Group of Experts on Road Signs and Signals

Report of the Group of Experts on Road Signs and Signals on its ninth session

A sign-by-sign assessment by the Group of Experts

A, 19 b “INTERSECTION WITH A ROAD THE USERS OF WHICH MUST GIVE WAY”

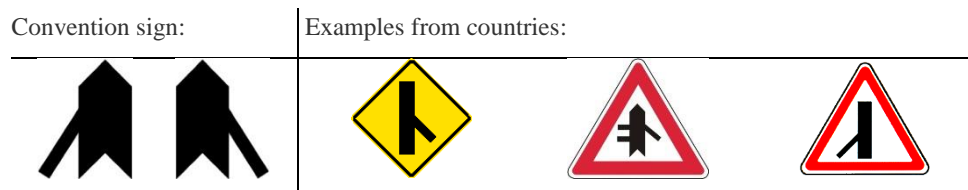
Some countries do not use the arrow head or the “V” shape at the bottom. The Group recommended using the symbol in the Convention without altering it (that is, having the arrow head and the “V” shape at the bottom). The Group clarified that the arrow head and the “V” shape at the bottom, and the differences in the proportion of the line widths, are essential characteristics of the symbol.

The Group suggested that the Convention should have as many examples of symbol A, 19 as it does for symbol A, 18.

A, 21 a and A, 20 b “INTERSECTION WITH A ROAD TO WHOSE USERS DRIVERS MUST GIVE WAY”

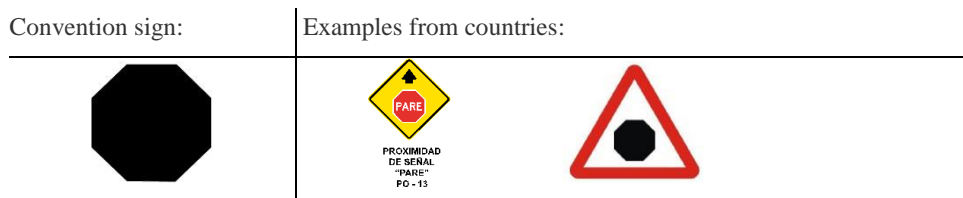
The Group noted that only a very few countries or none use the sign A, 21 a and A, 21 b while the majority of countries use the sign B, 1 supplemented by an additional panel bearing the “STOP” inscription and the figure indicating the distance to the sign B, 2 a or B, 2 b. This second possibility is introduced with paragraph 6 Article 10 (second sentence). However, the Group noted that both the paragraph 6 as well as point 20 (b) and 20 (c) of Section A of Annex 1 require that the same warning is implemented by different signs both being obligatory.

The Group recommended that giving advance warning of B, 2 a or B, 2 b should be done in accordance with paragraph 6 Article 10 while the sign A, 21 a and A, 21 b should be removed from the Convention.

The Group also recommended to amend para 6 of Article 10 as follows (second sentence):

To give advance warning of sign B, 2 a or B, 2 b, sign B, 1, supplemented by an additional panel bearing the "STOP" inscription, or its equivalent in national language, and a figure indicating the distance to the sign B, 2 a or B, 2 b shall be used.

B, 2 a “STOP”

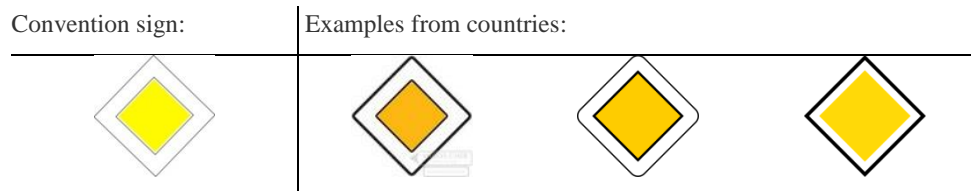
The Group recommended that, in relation to the signs used by the countries, the size of “Stop” should be in conformity with the size specified in the text of the Convention. The Group also recommended that the sign used in the Convention should be in conformity with the size specified in the text of the Convention.

B, 4 “END OF PRIORITY”

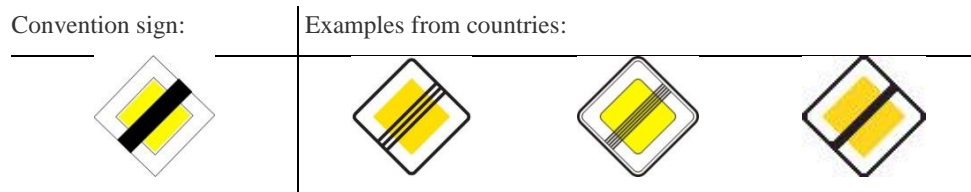
The Group recommended to amend the definition of sign B, 4 as follows:

The "END OF PRIORITY" sign shall be sign B, 4. It shall consist of sign B, 3 with the addition of a black median bar perpendicular to the lower left and upper right sides of the square or, preferably, of black parallel lines forming such a band.

Secretariat note: annex should show the B, 4 sign with three parallel lines.

B, 5 “PRIORITY FOR ONCOMING TRAFFIC”

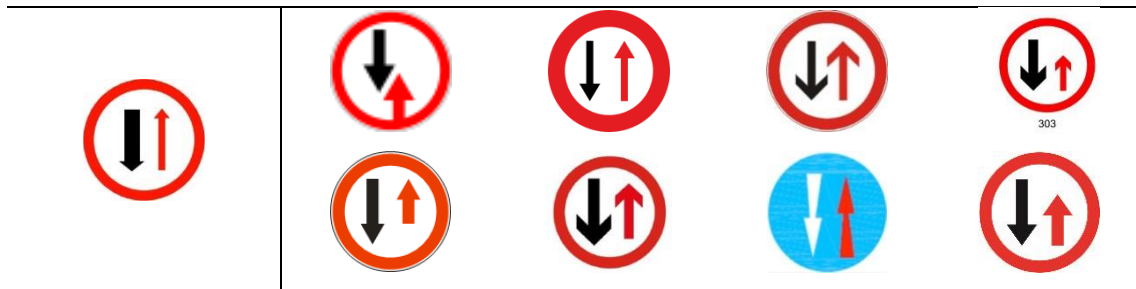
The Group noted that some countries do not use the arrows (ie length, width, positioning) as they appear in the Convention. The Group recommended that the arrowheads in the symbol used in Annex 3 of the Convention be enlarged, and that the signs of countries be in line with the revised symbol. The Group also recommended that the following additional words be inserted at the start of the article related to sign B, 5: “The sign indicating priority for oncoming traffic shall be sign B, 5.”

B, 6 “PRIORITY OVER ONCOMING TRAFFIC”

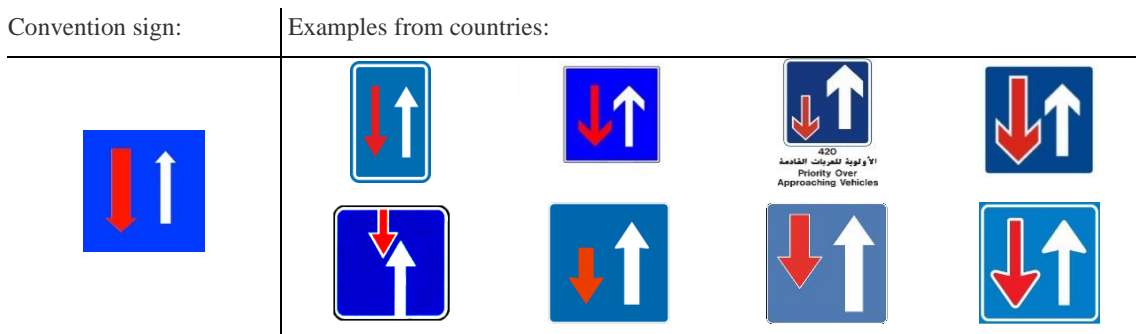
The Group noted that some countries do not use the arrows (ie length, width, positioning) as they appear in the Convention. The Group recommended that the arrowheads in the symbol used in Annex 3 of the Convention be enlarged, and that the signs of countries be in line with the revised symbol. The Group also recommended that the following additional words be inserted at the start of the article related to sign B, 6: “The sign indicating priority over oncoming traffic shall be sign B, 6.” To assist colour-blind drivers, the Group recommended that a white rim should be inserted around the red arrow.

C, 8 “NO ENTRY FOR VEHICLES HAVING A MASS EXCEEDING ... TONNES ON ONE AXLE”

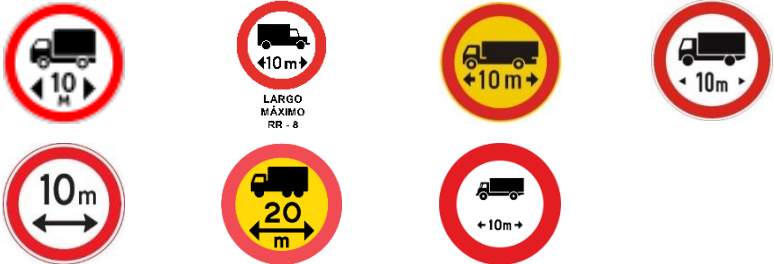
The Group noted that there was a difference in the casing of the symbol “T” (ie some countries use lower casing “t”), its positioning within the sign, and also that some countries used commas and period marks. The Group also noted differences in the arrowheads and axles. The Group believed that the symbol in the Convention should be modified from upper to lower casing (“t”) and that the positioning of the symbol “t” should appear where it currently appears in the Convention. The group also believed that the arrow should be deleted, replaced by one arrowhead and that the number used for the first digit in the Convention symbol should be larger.

Finally, the Group believed, that where a comma or period mark is used, that the second digit should be two-thirds the size of the first digit, and that the lower casing “t” should appear immediately after the second digit and at the same level, and be proportionately visible. If a fraction is required, the Group believed that it should be to the nearest tenth (ie 3.5t, 7.8t). If it is an integer (ie 7.00t), it should appear without any zeros or period marks (ie 7t).

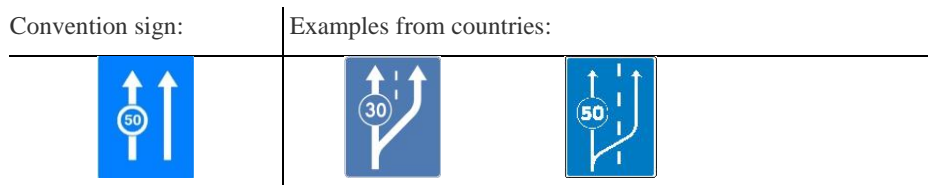
Albania, Croatia and Greece wrongly used examples for E, 1 a instead of E, 1 b.

Many countries use road markings (broken line) on this sign. The Group recommended the symbols on this sign not to include road markings ie., broken lines as the arrows indicate the “lanes”.

The Group recommended that for the E, 1 b sign the sign D, 7 is used with a white rim.

E, 1 c “SPEED LIMITS APPLYING TO DIFFERENT LANES”

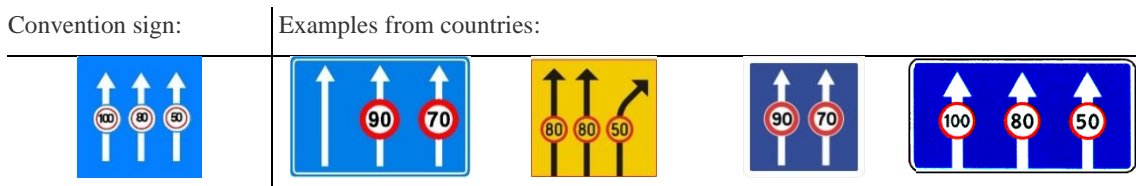
Azerbaijan used a wrong example for E, 1 c sign (truck entry prohibition sign instead of speed limit sign).

The Group recommended that the E, 1 c sign is improved by placing the sign C, 14 on the arrows and adding a white rim.

E, 2 a “SIGNS INDICATING LANES RESERVED FOR BUSES”

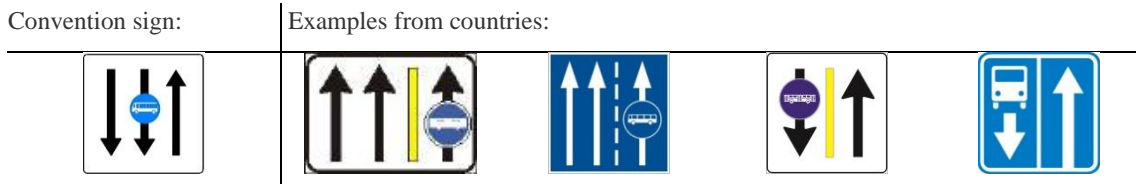
Article 26bis paragraph 2, Section E, sub-section II, point 2 and E, 2 a and E, 2 b reproductions in Annex 3 do not appear to be consistent and thus do not clearly define signs E, 2 a and E, 2 b.

Several countries (Azerbaijan, Belgium, Croatia, Latvia, Luxembourg, Montenegro and Ukraine) use examples for E, 2 a that do not correspond to the examples of the Convention.

Many countries use road markings (broken or continuous line) on this sign. The Group recommended the symbols on this sign not to include road markings as the arrows indicate the “lanes”.

E, 2 b “SIGNS INDICATING LANES RESERVED FOR BUSES”

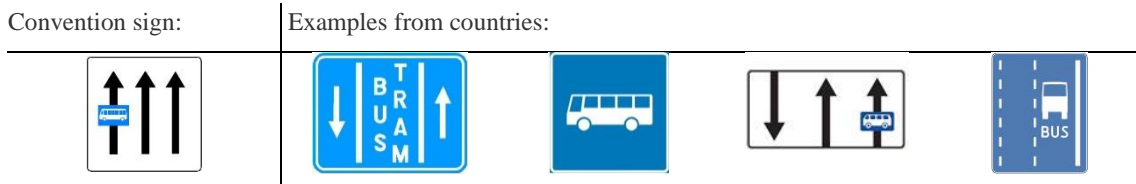
Several countries (Belgium, Croatia, Finland, Latvia, Montenegro, Poland and Ukraine) use examples for E, 2 b that do not correspond to the examples of the Convention.

Many countries use road markings (broken or continuous line) on this sign. The Group recommended the symbols on this sign not to include road markings as the arrows indicate the “lanes”.

The Group noted a spelling mistake in Article 26 bis paragraph 2. Second sentence should read “The sign indicating such a lane”
